## **Response to Comments**

**Modification of the *Hanford Facility*  
*Resource Conservation and Recovery Act*  
*Permit for the Treatment, Storage, and*  
*Disposal of Dangerous Waste, Part III,*  
**Operating Unit Group 10 (WA7890008967)**  
**Waste Treatment and Immobilization Plant**  
**8c.2016.4F**  
**December 28, 2015 through February 13,**  
**2016****

*Summary of a public comment period and responses to comments*

Figure C-36 LVP-SCB-00001 Aqueous PCDS

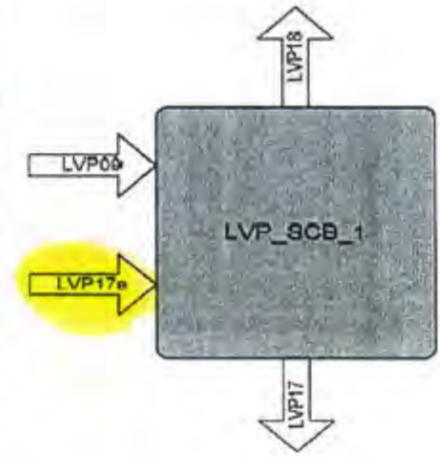
And Does not  
Address  
DILAW  
Feed Spec  
"Envelope E"

ISOMETRIC VIEW  
OFFGAS CAUSTIC SCRUBBER ASSEMBLY

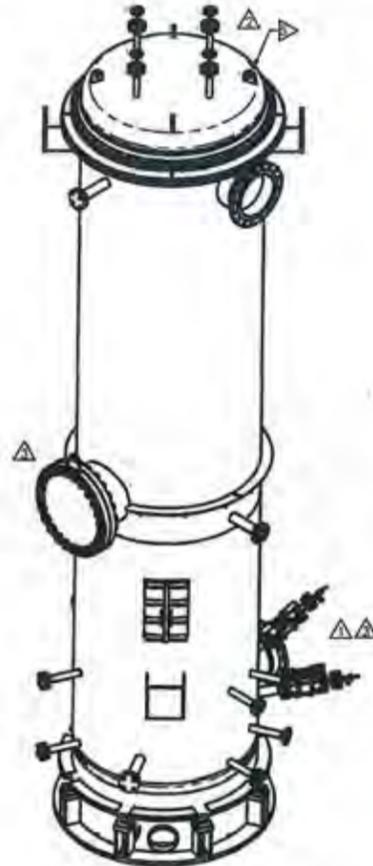
In addition, drawing 24590-QL-POA-MKAS-00003-04-00050 Rev 0E does not identify the material of construction for the internal structure and packing support in the scrubber. Nor does this drawing have a corrosion allowance for the packing support. Will it be durable under both the full range of caustic and acid flush conditions?

BECHTEL NATIONAL  
 PROJECT: RPP-WTP  
 PROJECT NO.: 24590  
 PO NO.: 24590-CO-POA-MEEO-00003, REV. 0  
 EQUIPMENT NO.: LVP-HTR-00001B, LVP-HTR-00003B  
 LOCATION: RICHLAND, WA

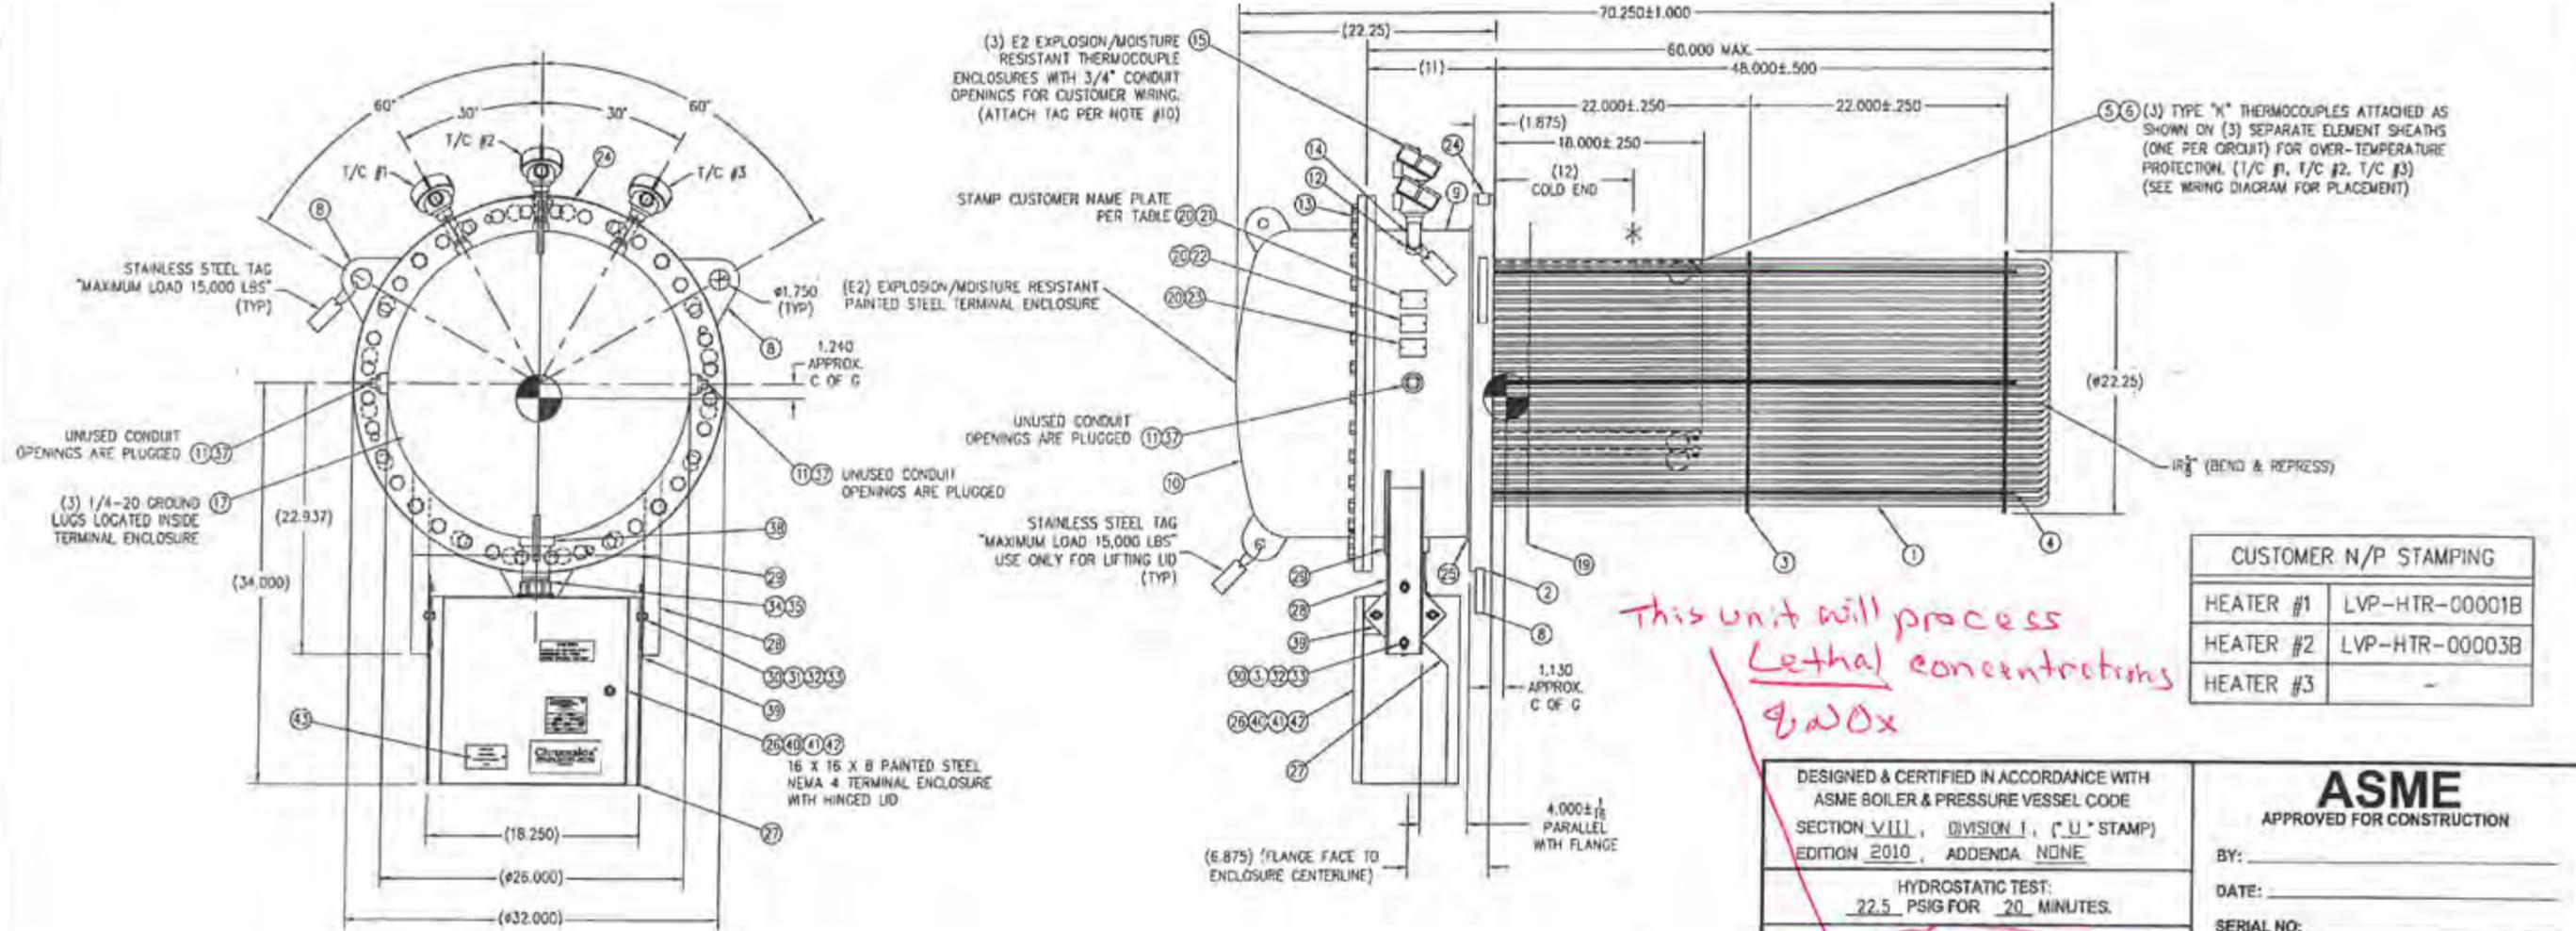
Drawing 24590-CD-POA-MEE0-00003-03-00004, “Immersion Heater Flanged” identifies the heated medium as air with “no lethal substances” instead of a process toxic off-gas. See sheet 1, Sheet 3 of this drawing shows the number of commercial grade material specifications. The absence of a commercial grade dedication report in the permit package is contrary to the requirement that a final permit contain a *description of procedures, structures, or equipment used at the facility to prevent undue exposure of personnel to dangerous waste, and prevent releases to the atmosphere*. Without a commercial grade dedication report, the features needed in the heater to prevent releases to the workers cannot be verified as effective.
